Approved and proposed elevations

This application is for a minor-material amendment (Section 73) to the approved application **2016/4663/P**, to vary condition 4.

Highgate Piano Factory 1A Highgate Road

Proposed External Works

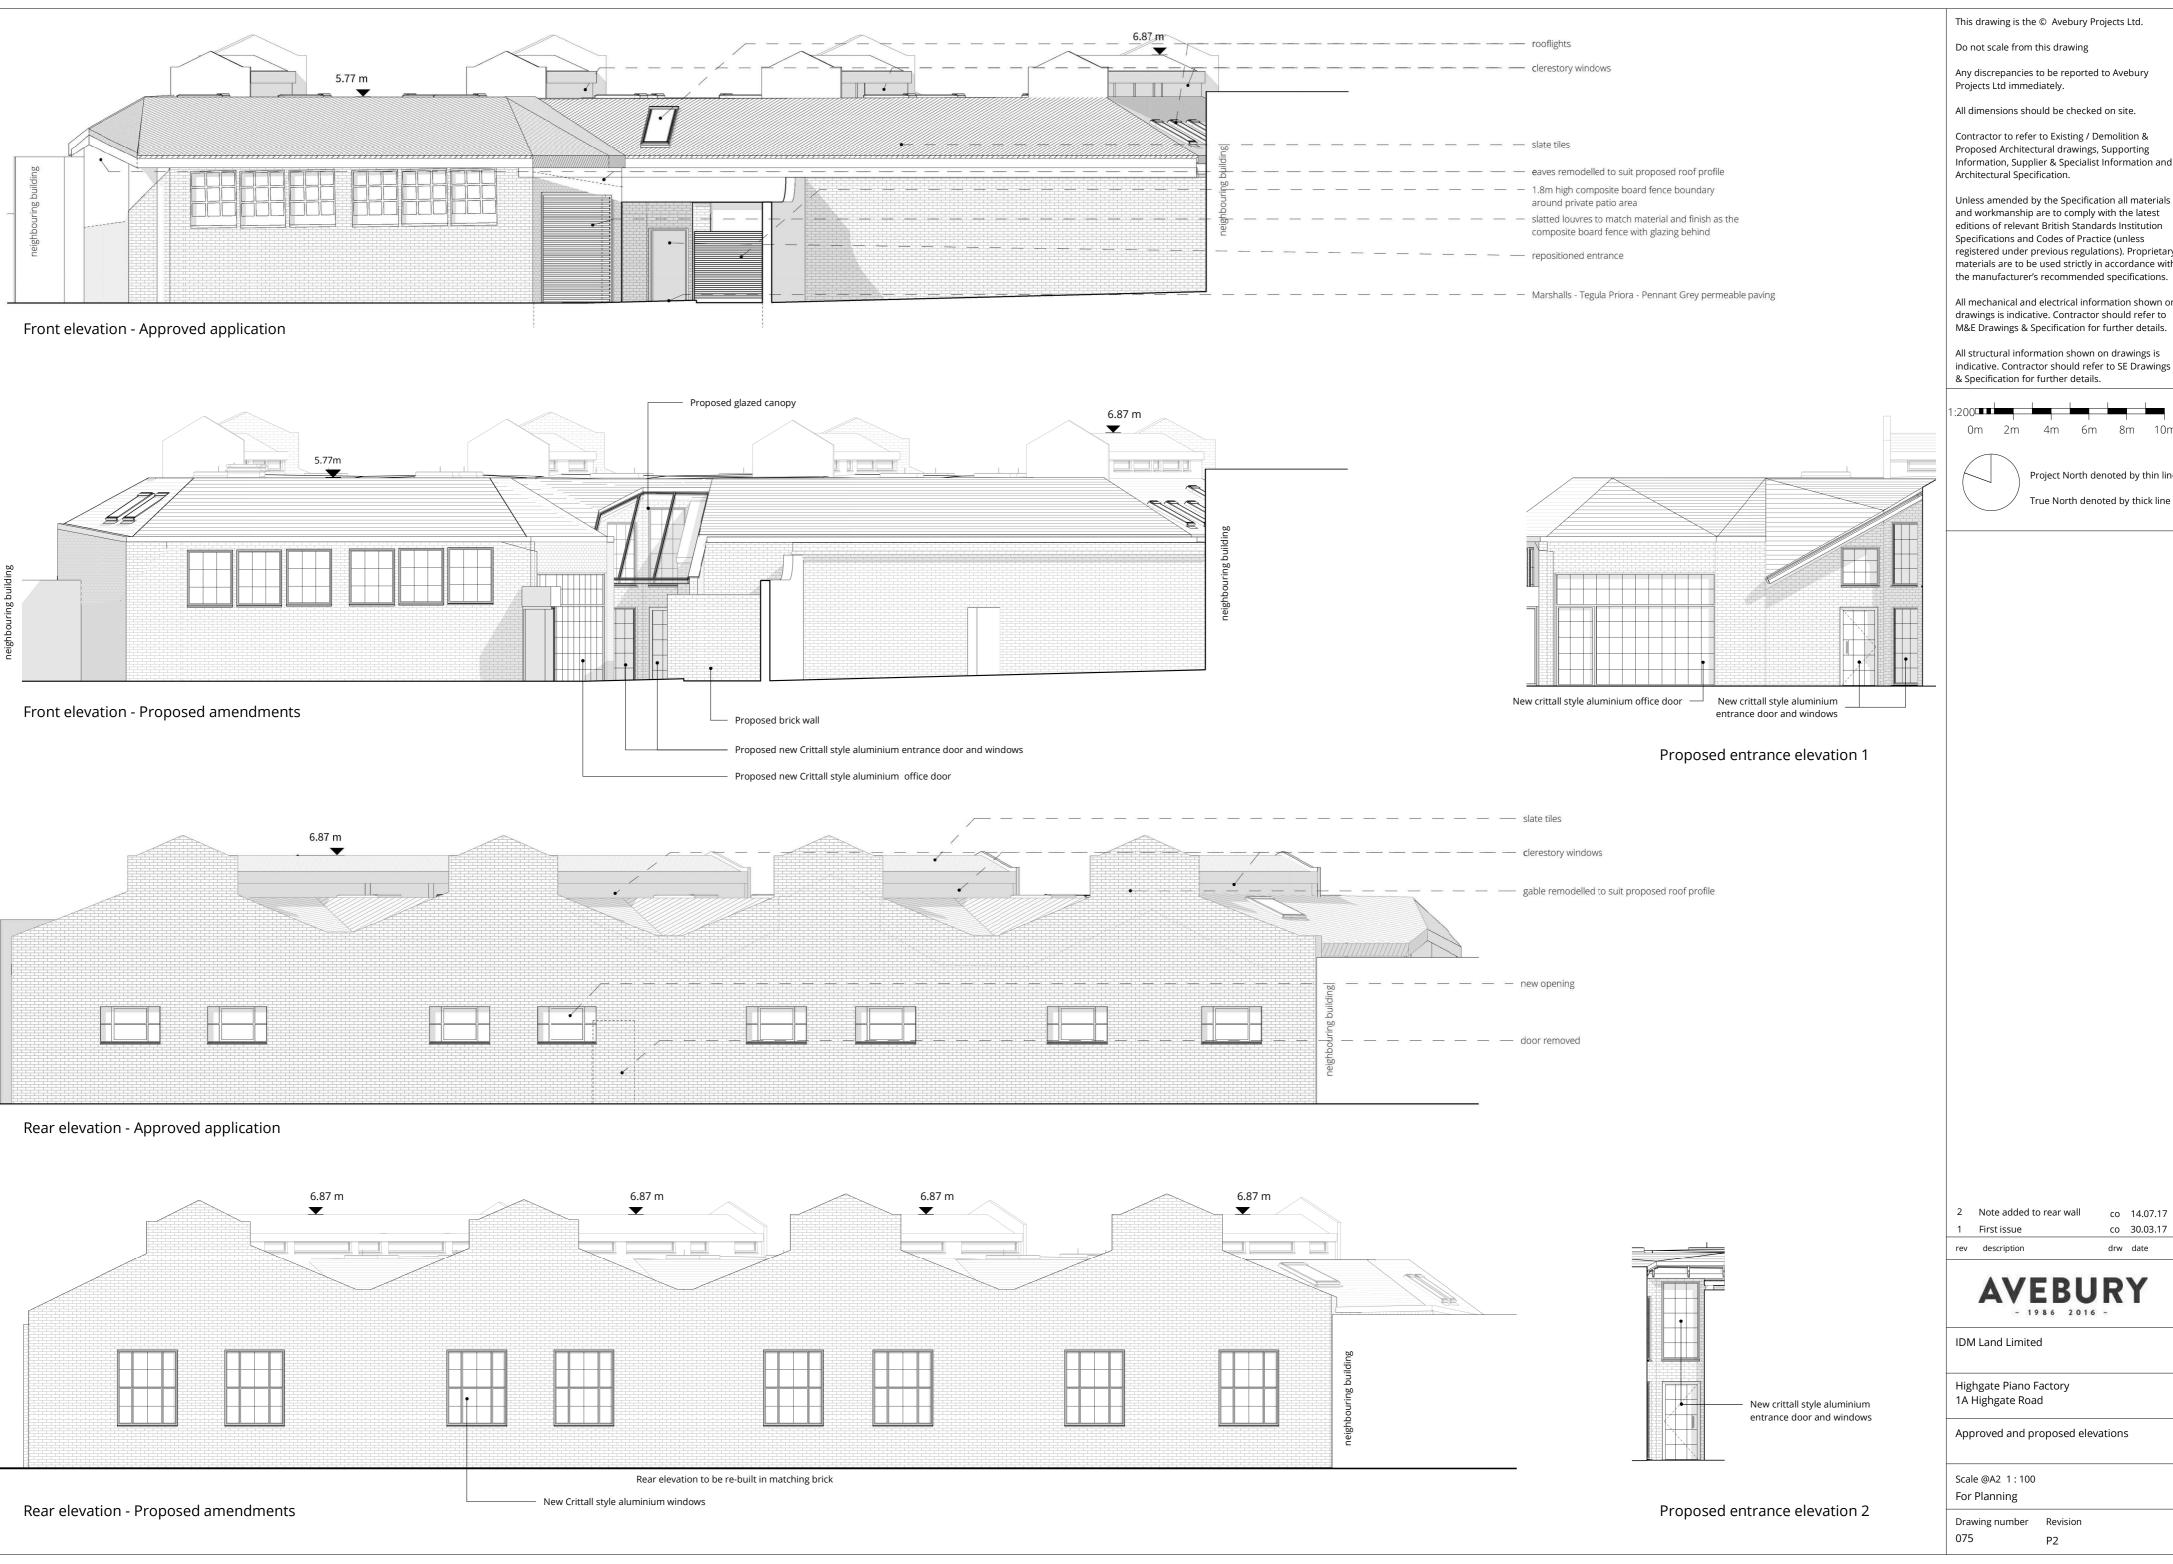
- 2. Addition and relocation of roof lights to improve the internal environment of the building.
- 3. Creation of a glazed canopy over the building entrance.

- 4. Alteration of windows to the rear to provide more daylighting into the building.
- 5. Alteration of approved external windows to change them to Crittall style aluminium windows, finished in dark grey, RAL 9004.

- This is to ensure the style of the windows is more in keeping with the nature of the building.
- 6. Alteration of the office door from slatted louvers to a Crittall style aluminium door. *This is to ensure the style of the office door is more in keeping with the nature of the building.*

- 7. Addition of windows above the entrance doors.
- 8. Alteration of external 1.8m high composite fence to 2.4m high white painted brick wall. A white painted brick wall will match more closely to the style of the existing building than a new composite fence.

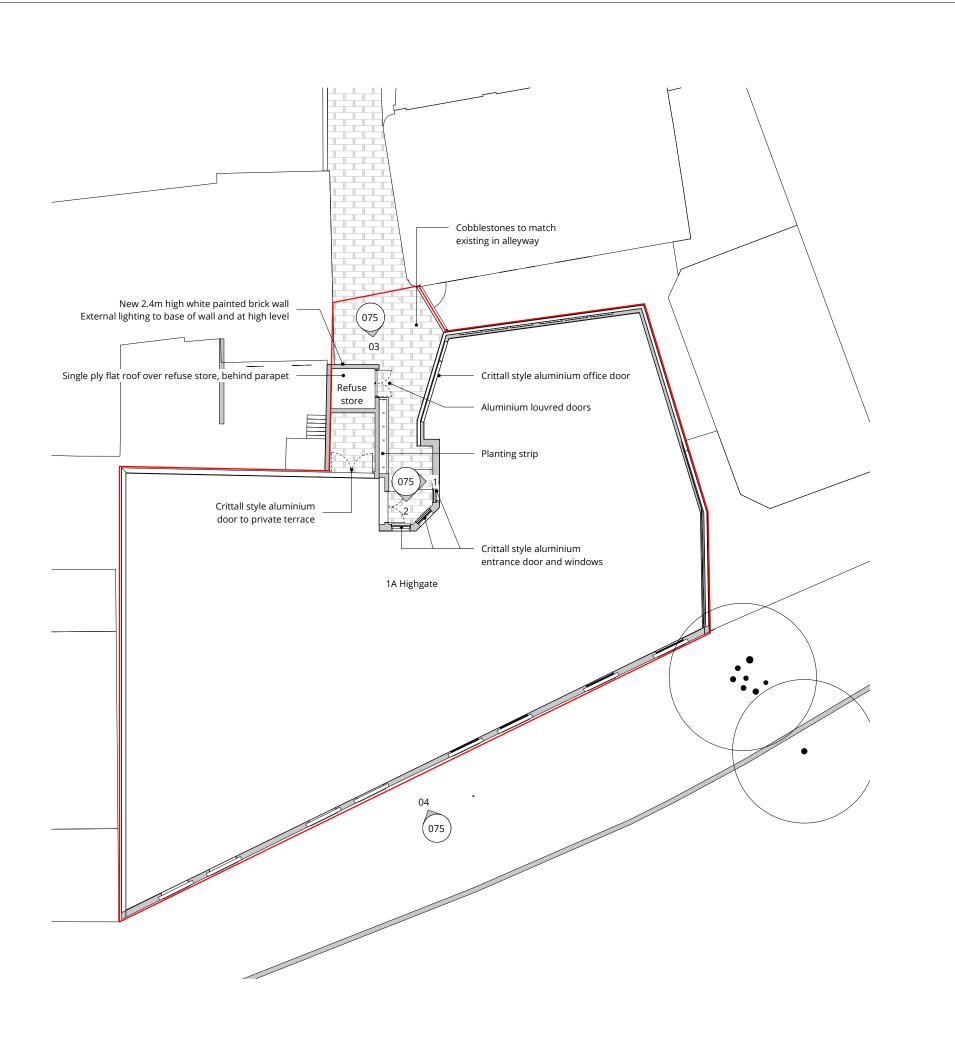
- 9. Alteration of external paving from Marshalls Tegula paving to cobblestones to match the existing stones in the alleyway.
 - Cobblestones similar to the existing will ensure the access path compliments the style of the surrounding area.

- Note that the other approved external materials for the roof & roof lights remain unchanged.
- 10. Addition of a planting strip and external lighting to the entrance area.
